**SAFETY EVALUATION REPORT
REVIEW OF REQUEST FOR PAGE CHANGES TO THE TECHNICAL REPORT,
SURETY UPDATE, AND THE ADDITION OF TWO VACUUM DRYERS
LOST CREEK ISR, LLC LOST CREEK PROJECT
SWEETWATER COUNTY, WYOMING**

Docket No.: 40-9068

License No.: SUA-1598

Date: April 18, 2013

Figure 11-1. Revised Lost Creek Project Schedule

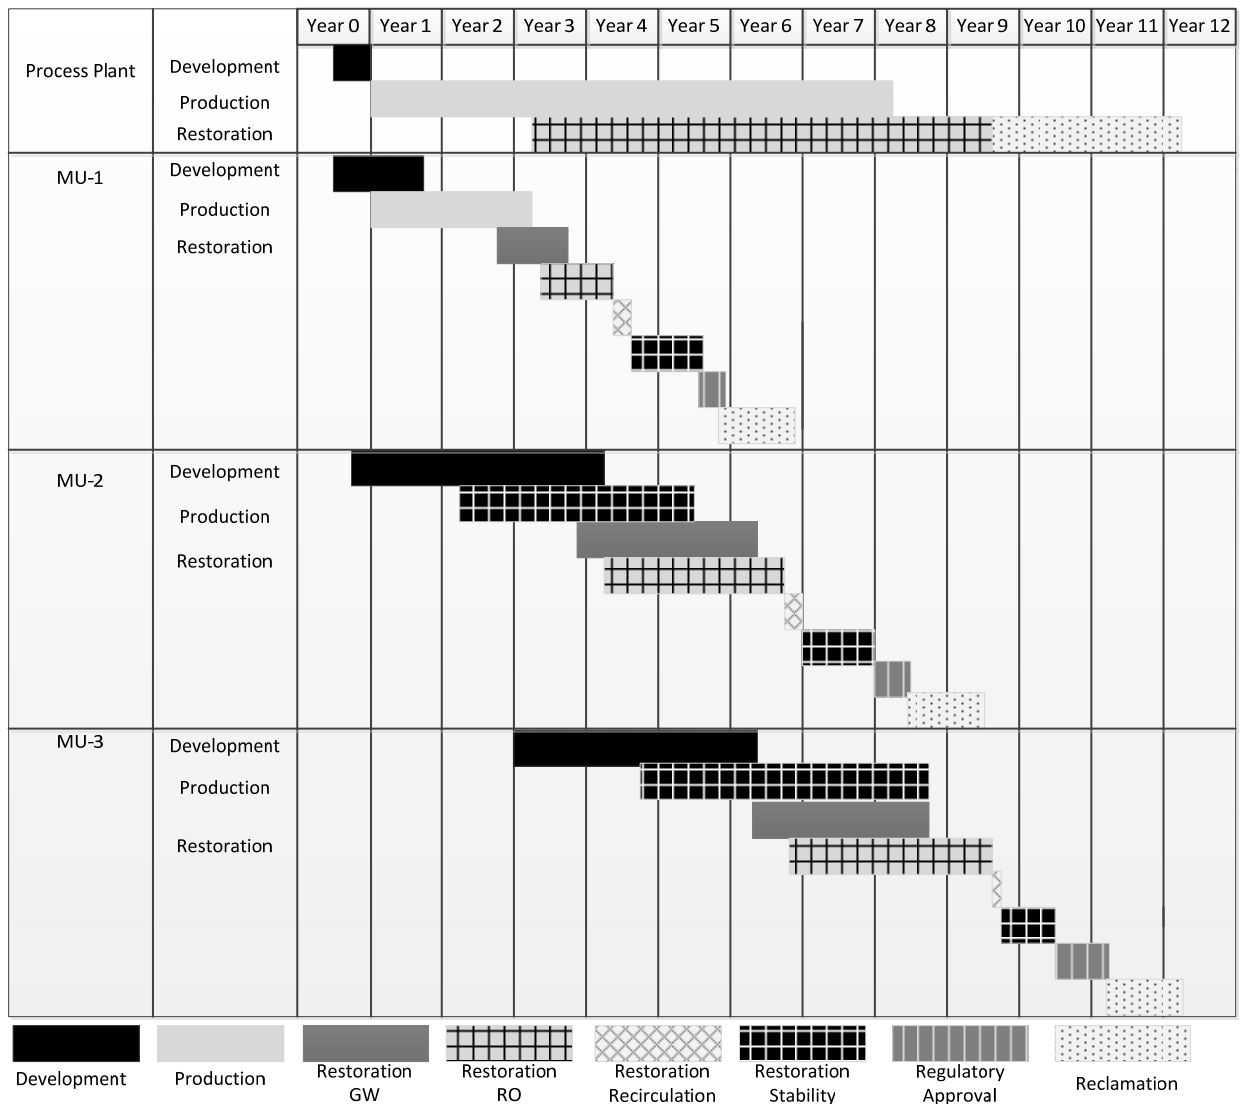
Subsequent to issuance of the NRC Source Material License SUA-1598 (NRC, 2011e), the licensee established a Safety and Environmental Review Panel (SERP) (LCI, 2012a). The SERP has reviewed and approved all facility design changes submitted to the NRC, to include the addition of two rotary vacuum dryers. As described in TR Section 3.1, the original proposed design included three process circuits.

NRC Source Material License SUA-1598 (NRC, 2011e) allows three major processing circuits in the processing plant: ion exchange (IX), elution, and precipitation/filtration. Equipment located in the plant will include IX and elution vessels, precipitation tanks, filter presses, storage tanks, and the associated piping, pumps, and valves required to be able to move the solutions throughout the plant. The licensee's application to amend the license adds a fourth process circuit, the dryer circuit, which will give LCI the option of producing dried yellowcake as a final product in addition to the option of yellowcake slurry production (LCI, 2012a). Allowing both options will enable the licensee to continue production uranium operations regardless of whether or not the vacuum dryers are operational because yellowcake slurry could still be shipped to a licensed facility for processing. The licensee submitted a revised technical report Plate 3.1-1 (also a revised environmental report Plate.2-1) that illustrates the amended processing plant layout.
